June 21, 2021

Re: TransPort Colorado Water Tank Site Plan DA-1793-14 Response to Submittal #2

TRANSPORT COLORADO INFRASTRUCTURE SITE PLAN 01

0.00	COVER SHEET
C1	GRADING PLAN
C2	UTILITY PLAN
C3	DETAILS
L1.01	SITE PLAN
L2.01	DETAILS SHEET

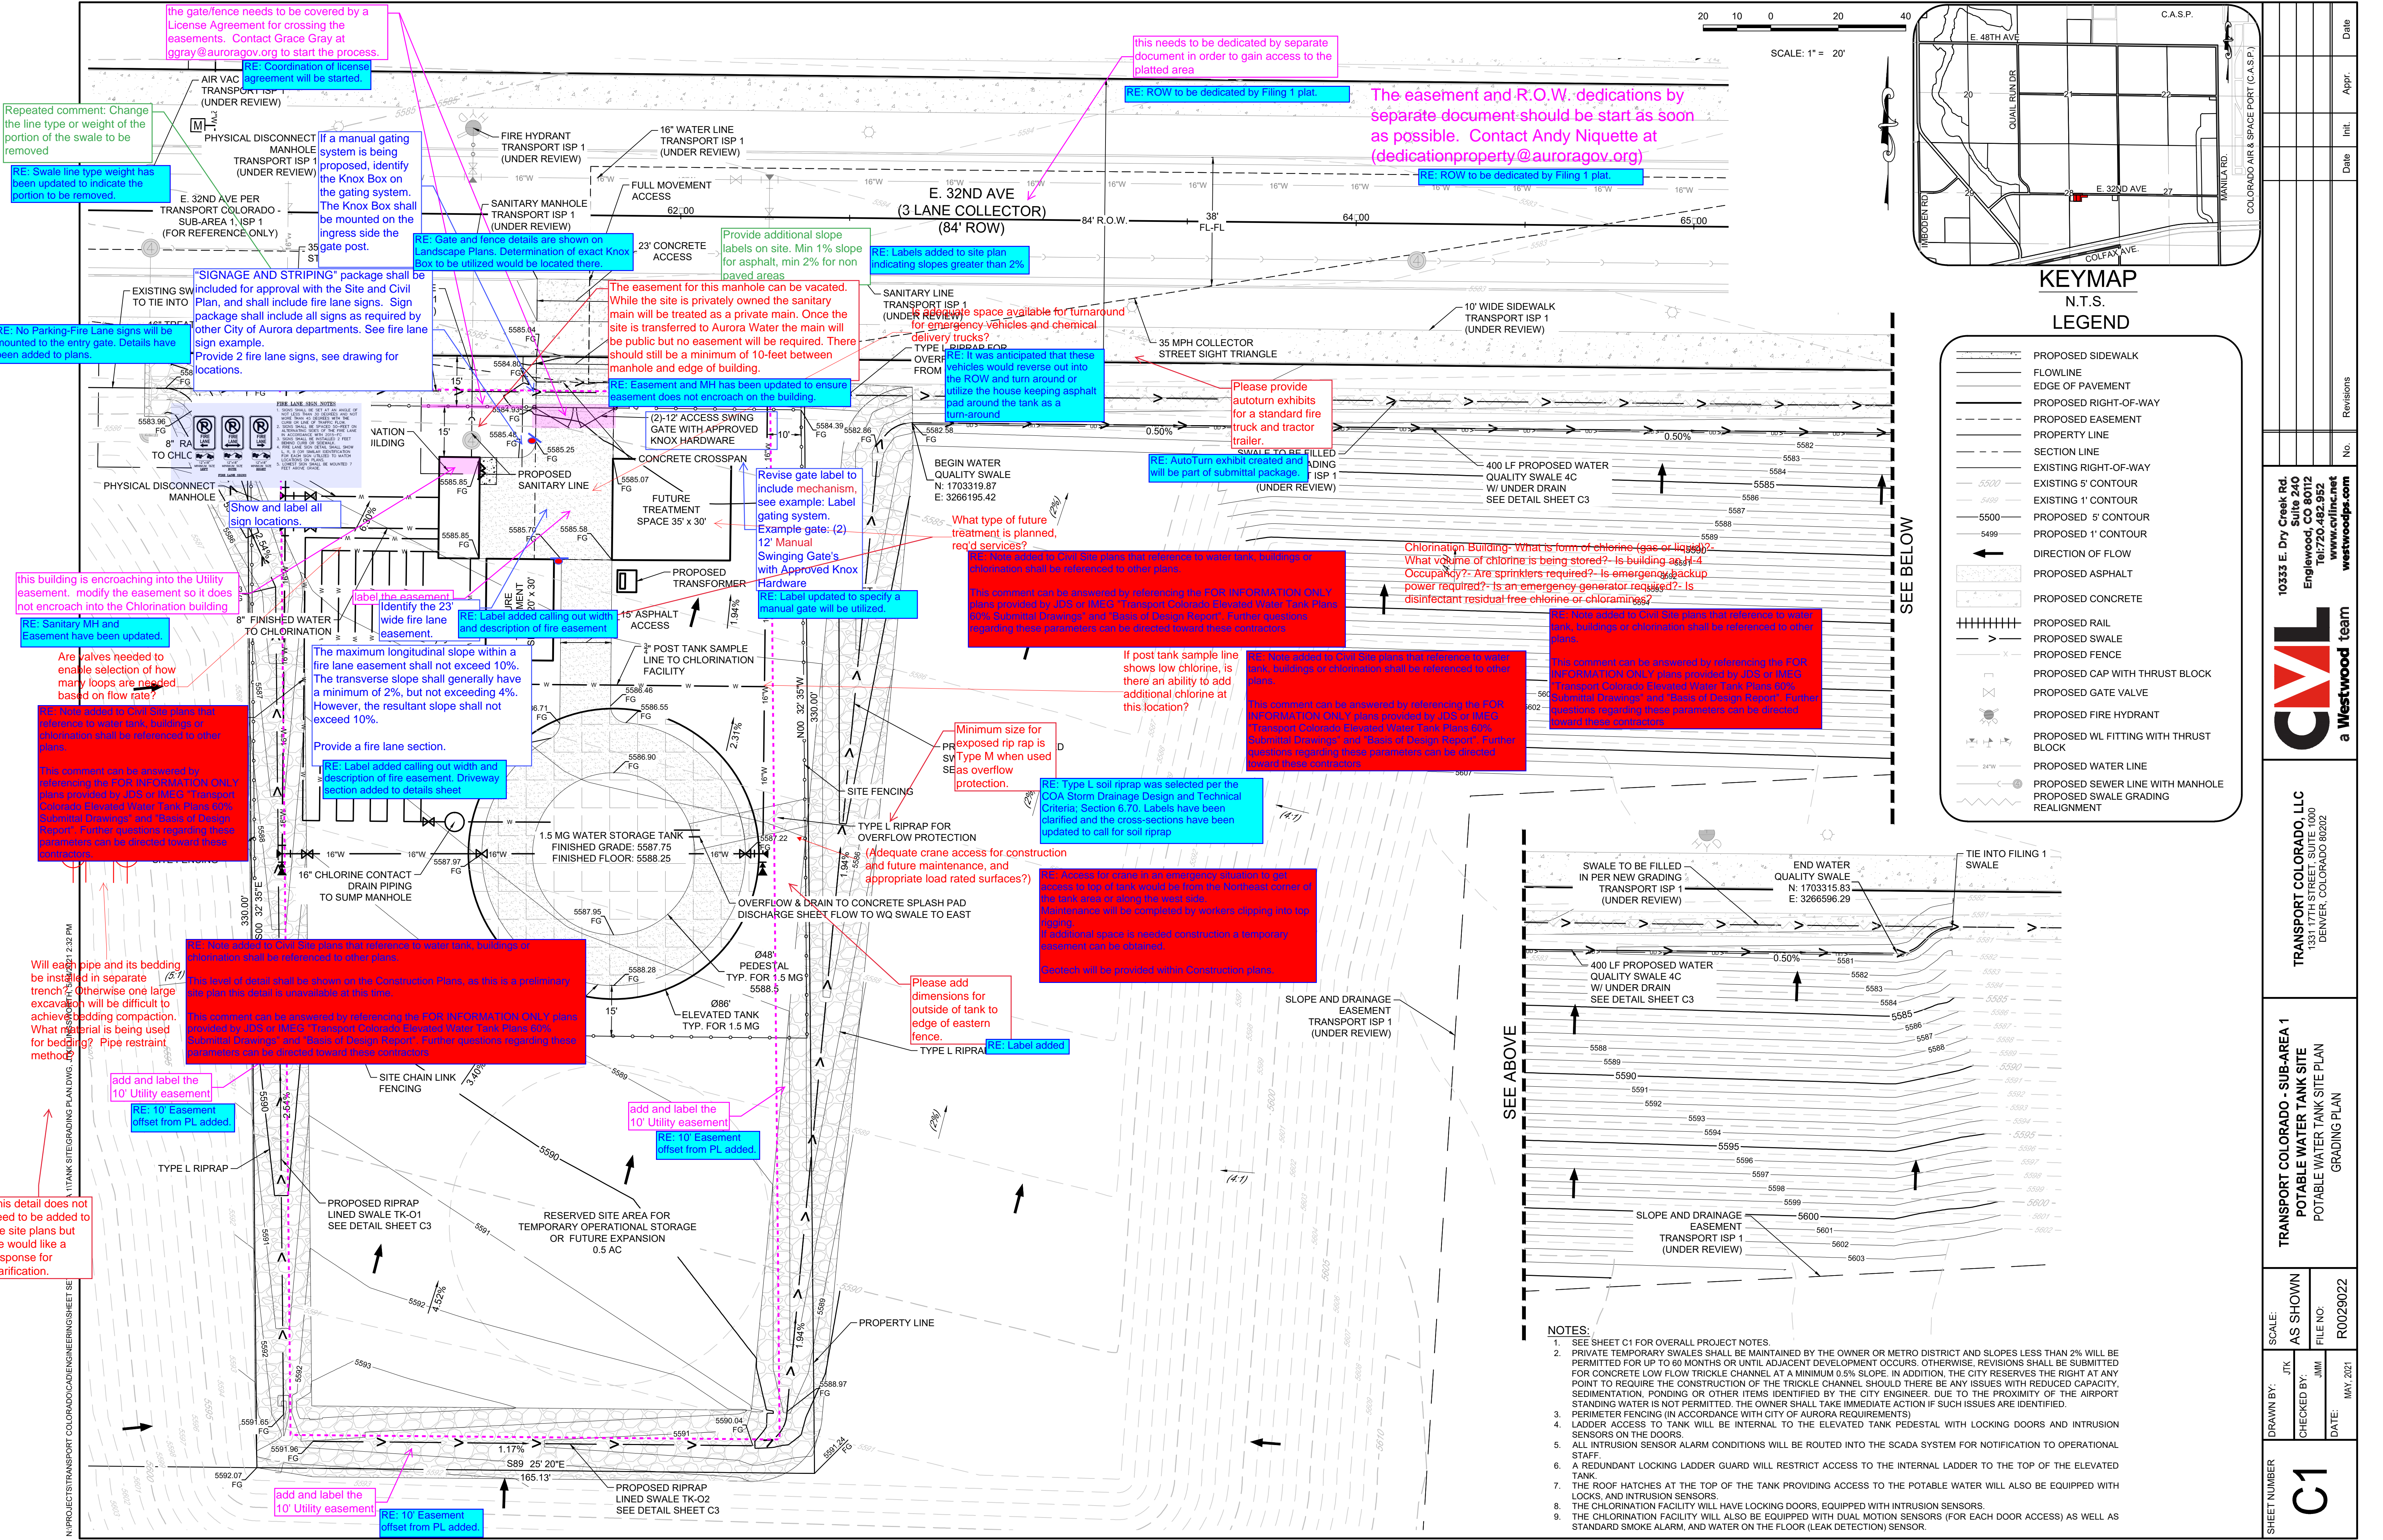
Typically, site plans have a table of contents, which includes a site sheet. Please check with your planner if any additional sheets are required.

RE: Sheet index is included on Cover Sheet in lower right corner

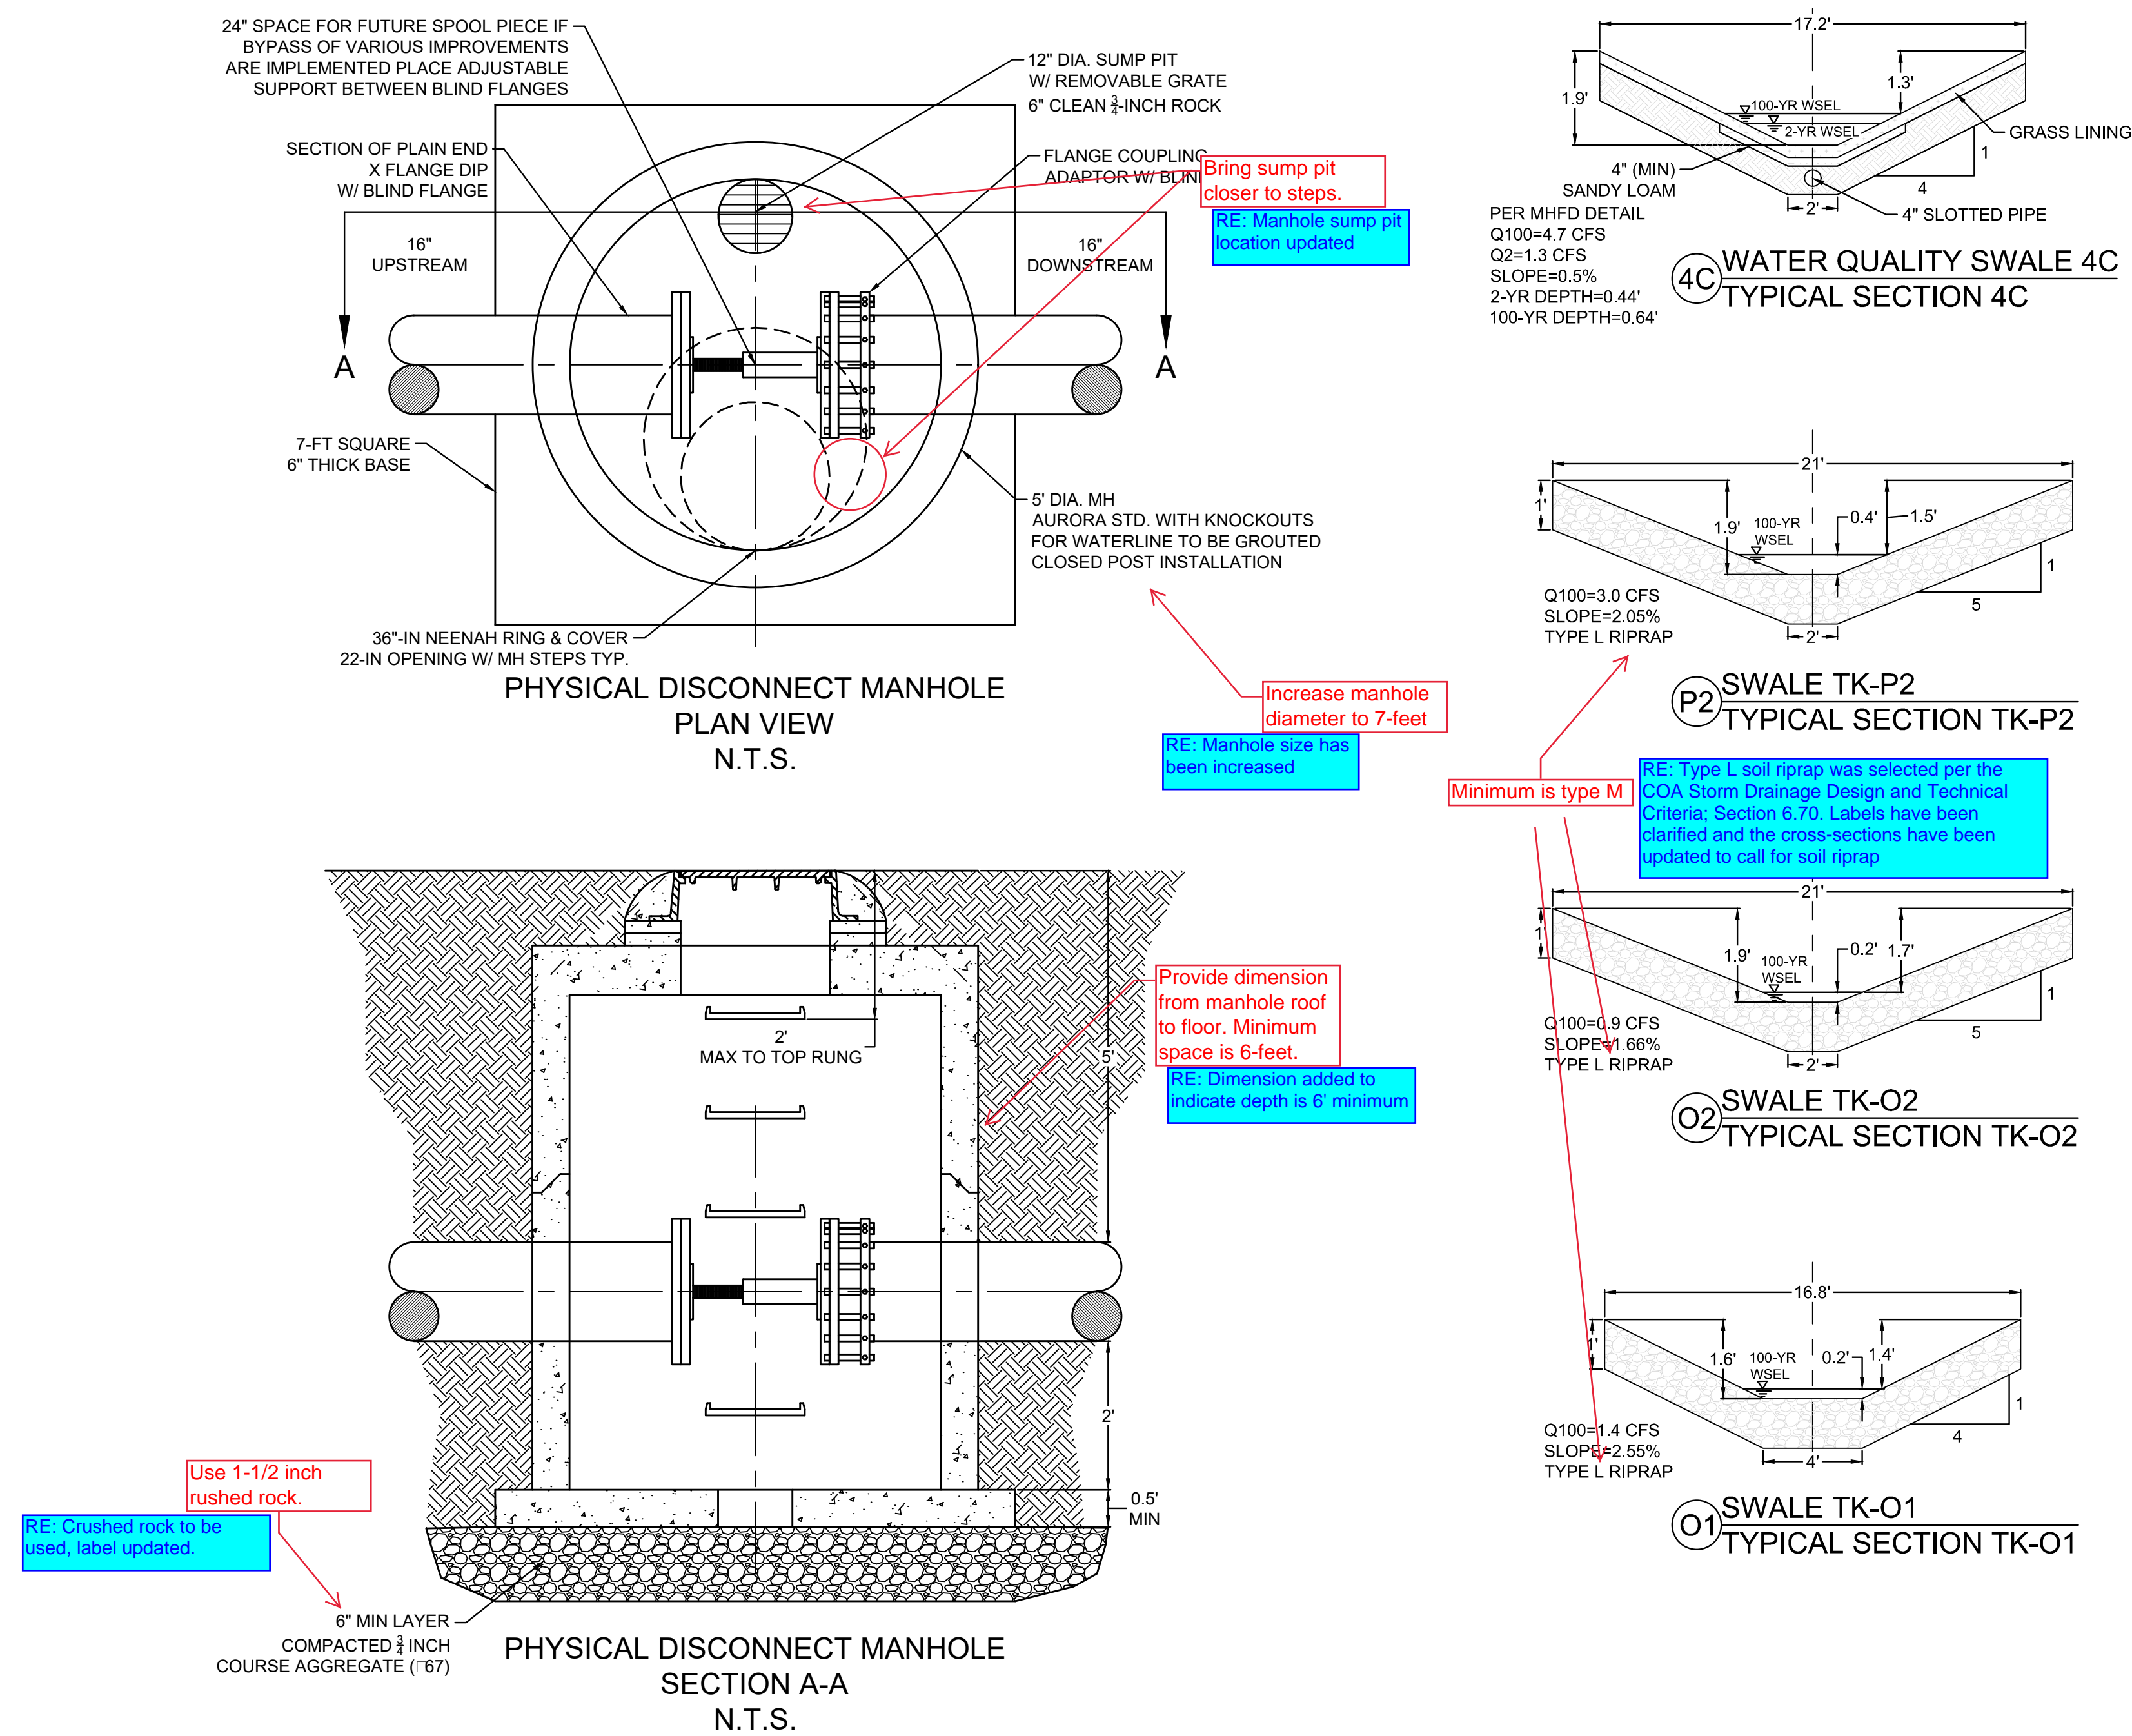
6.H Increase manhole diameter to 7-feet.

6.J Provide dimension from manhole roof to floor. Minimum space is 6-feet.

6.K Use 1-1/2 inch crushed rock.

RE: Physical disconnect manhole detail has been updated.

RE: Physical disconnect manhole detail has been updated.

RE: Physical disconnect manhole detail has been updated.

A PART OF THE SOUTHEAST QUARTER OF SECTION 28, TOWNSHIP 3 SOUTH, RANGE 64 WEST OF THE 6TH P.M.,
CITY OF AURORA, COUNTY OF ADAMS, STATE OF COLORADO
SHEET 3 OF 3

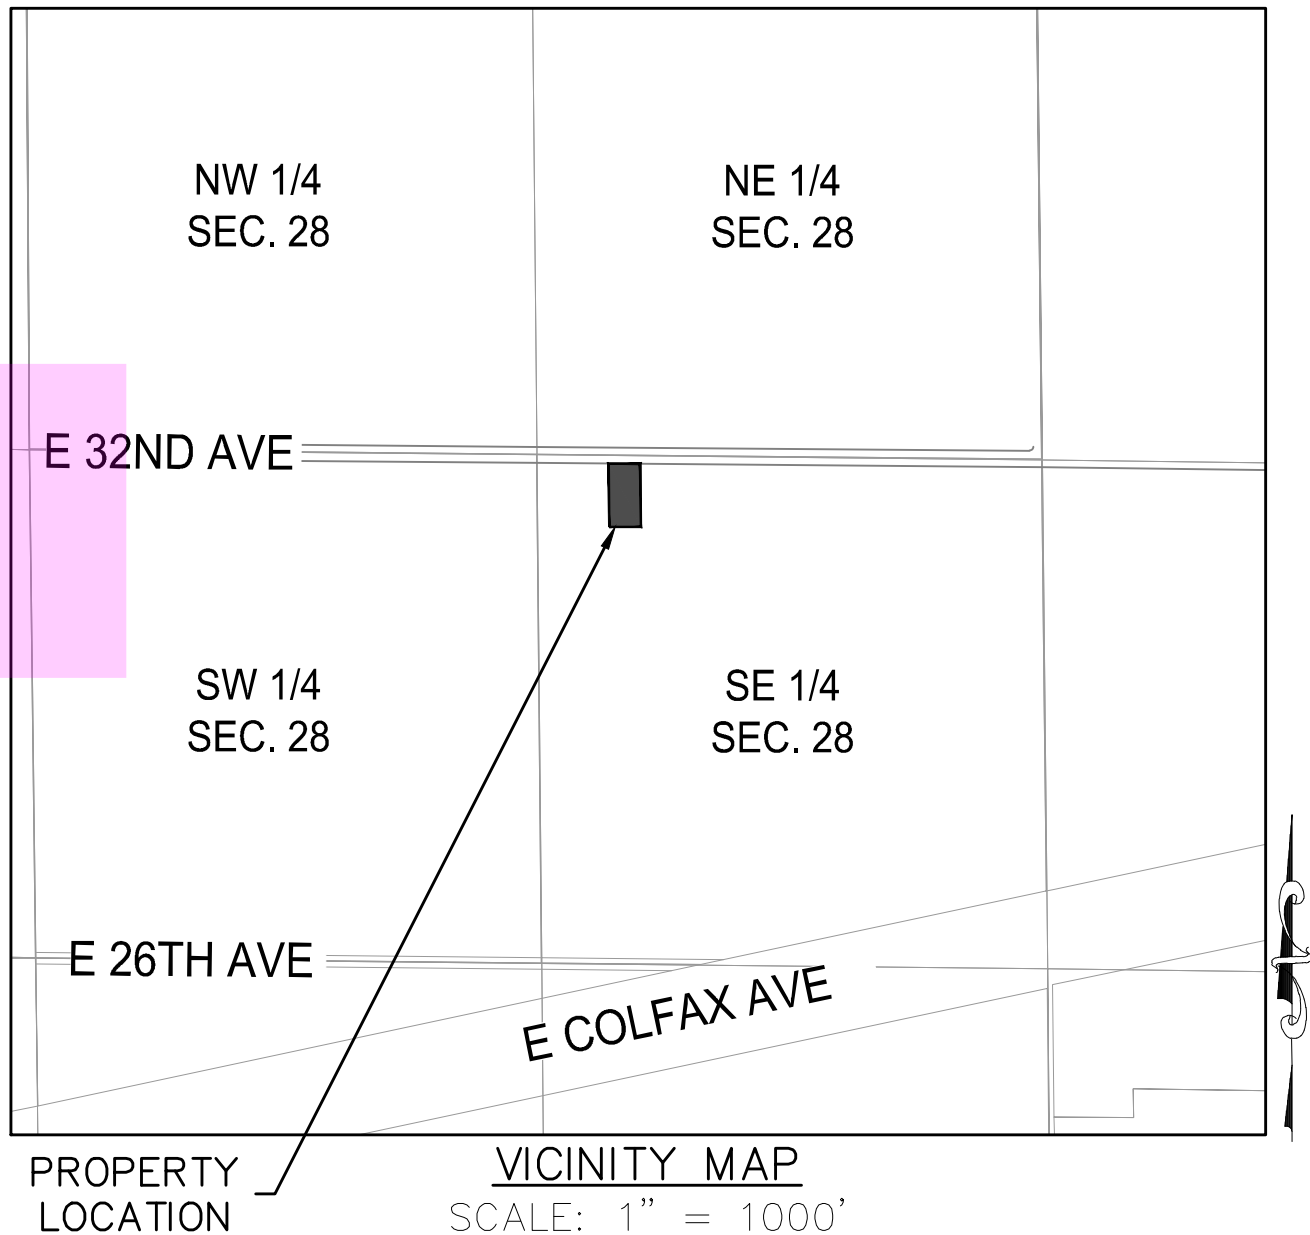
The easement and R.O.W. dedications by separate document should be start as soon as possible. Contact Andy Niquette at (dedicationproperty@auroragov.org)

ROW IS IN THE PROCESS OF BEING SUBMITTED
